**Planning Commission
Council Chambers
January 18, 2022 – 6:00 p.m.
233 South Main Street, Monroe, Ohio**

TO: Members of the Monroe Planning Commission
FROM: Kameryn Jones
Assistant Development Director

DATE: January 18, 2022
RE: Information Packet for January 18, 2022 Planning Commission Meeting at 6:00 p.m.

C-2

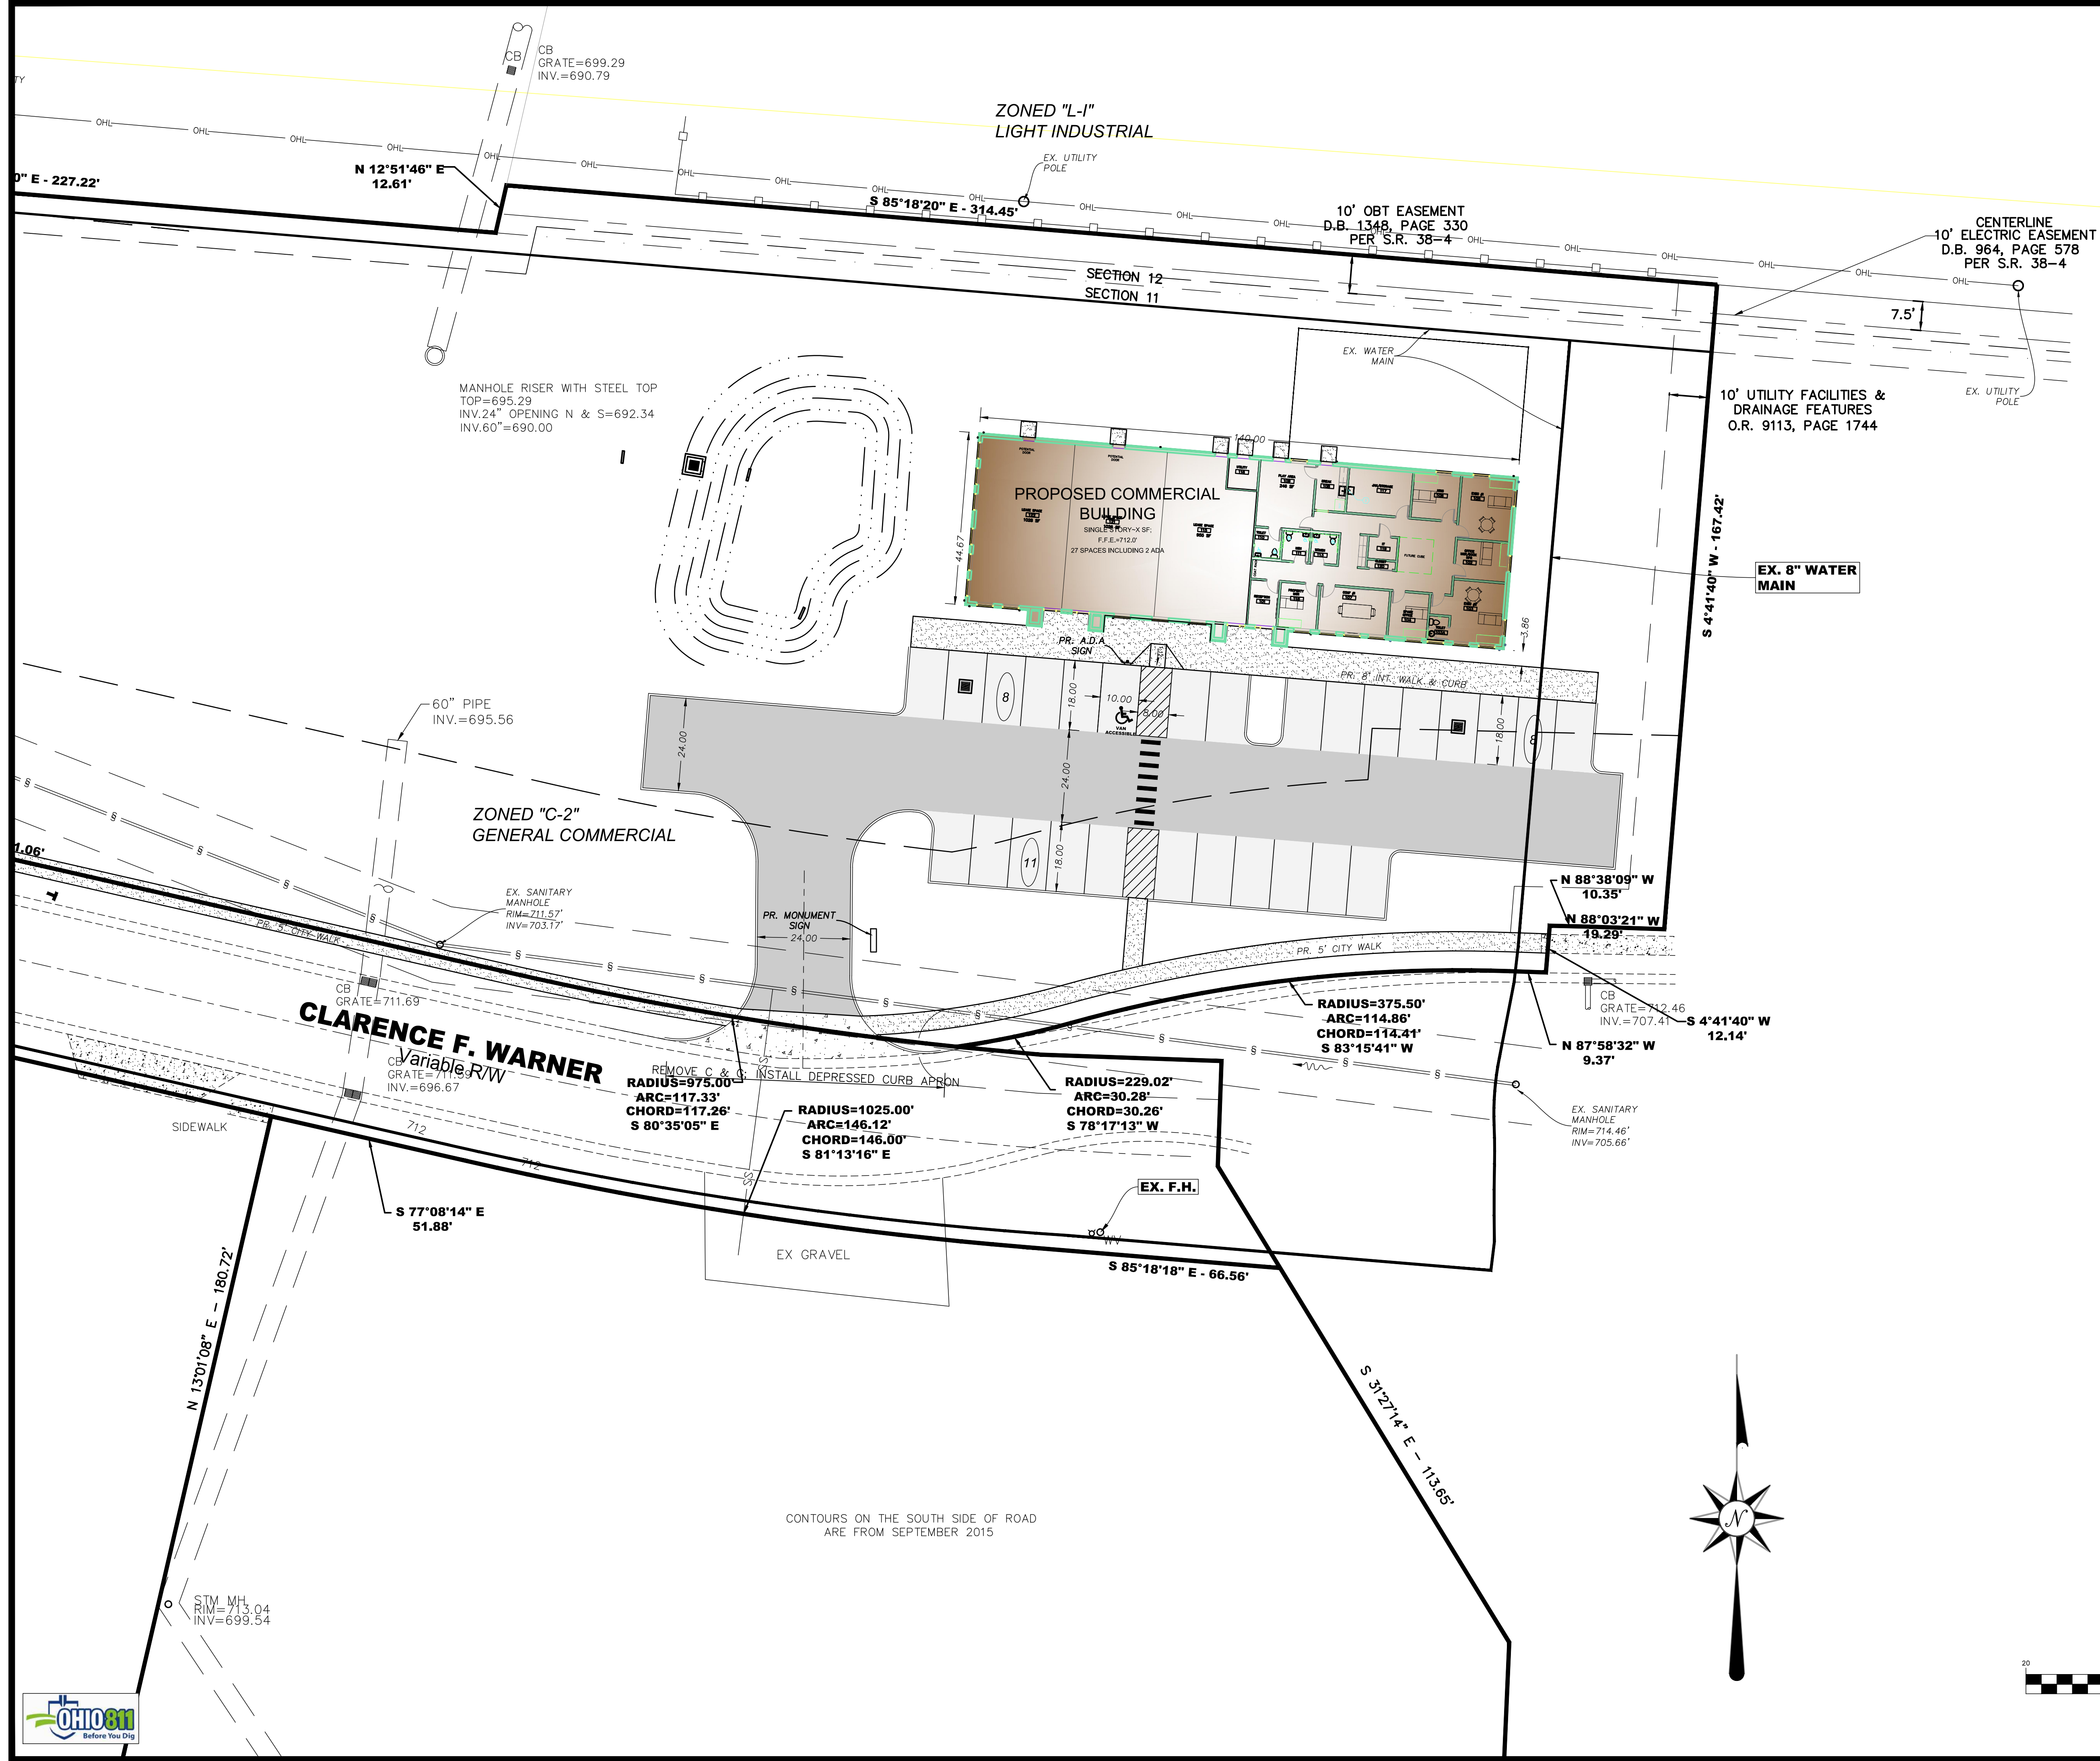
5. Sheet C-2:
 - Existing conditions plan need revisions to show actual water main locations at American Way and include all perimeter valving, etc. LCNB bank plans completed by CCC previously show water main loop across Clarence F Warner Dr Drive, actual locations do not support this as evidenced during installation of Arby's water line. Revisions needed to plans or confirmation of completion needs to be shown and provided.

C-3

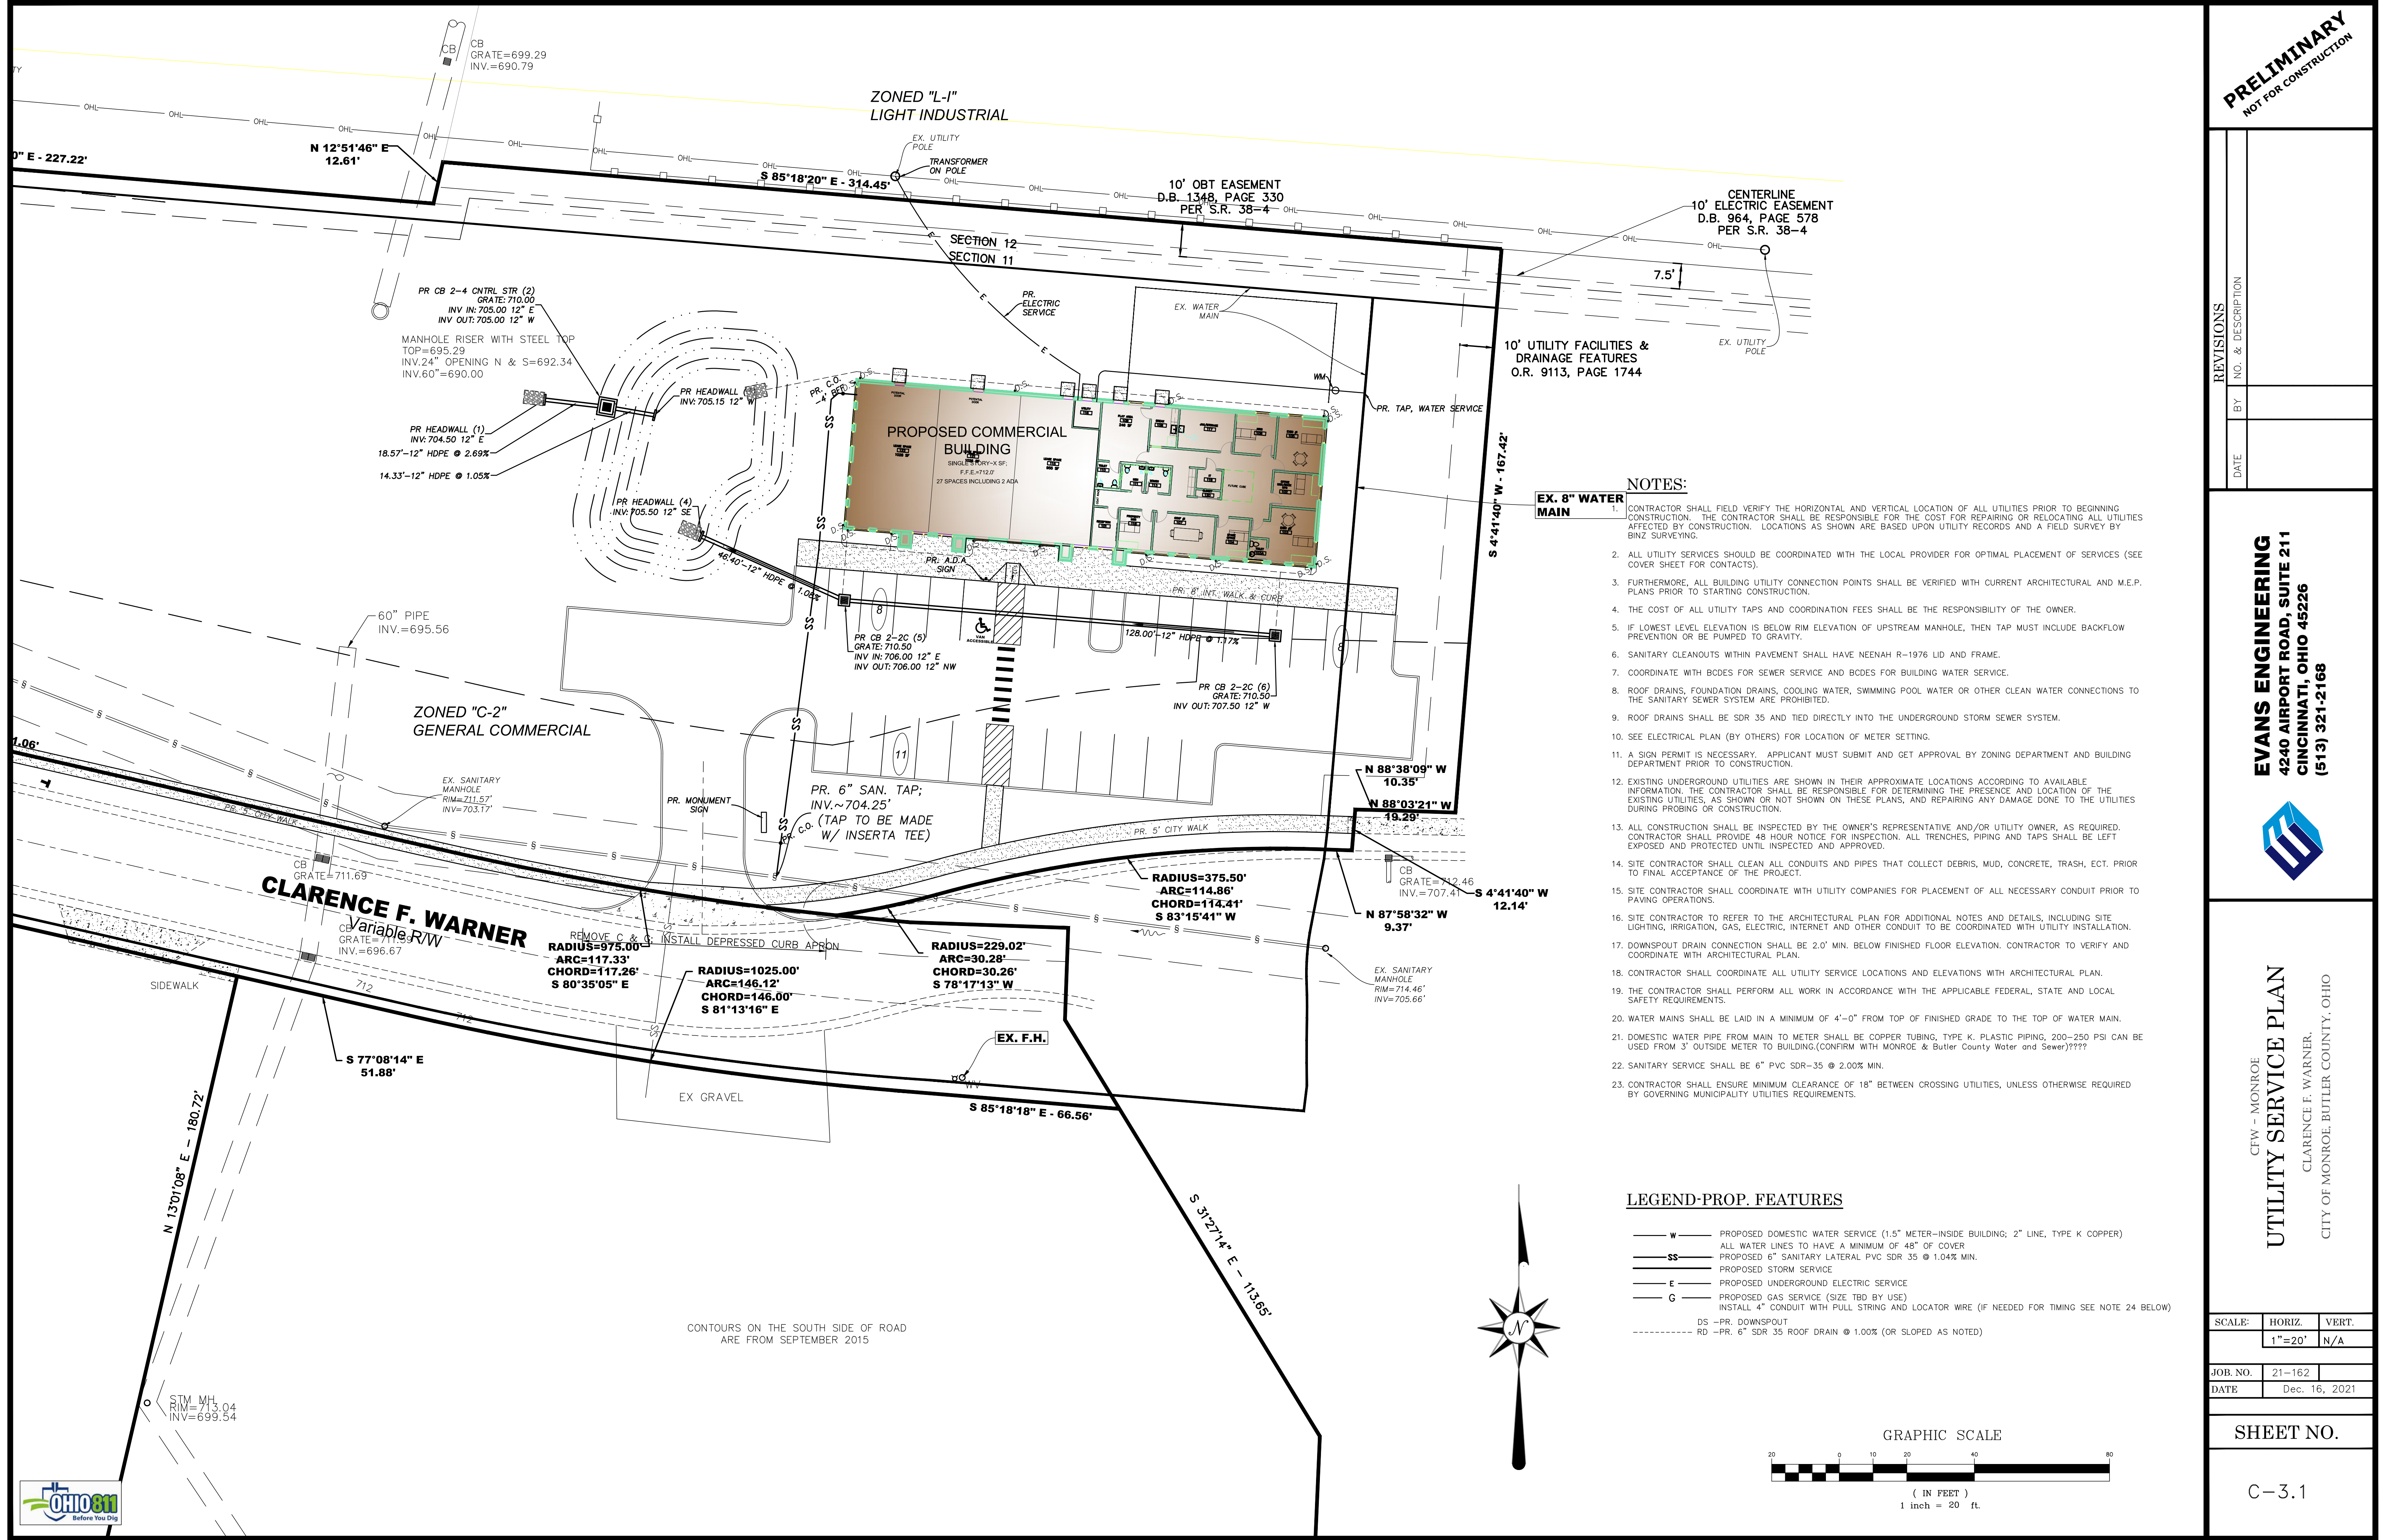
- Revise plans to include walk on south side of Clarence F Warner Dr.
 6. Sheet C-3/C-3.1 (and other affected sheets)
 - Plan need revisions to show actual water main locations at American Way and include all perimeter valving, etc.
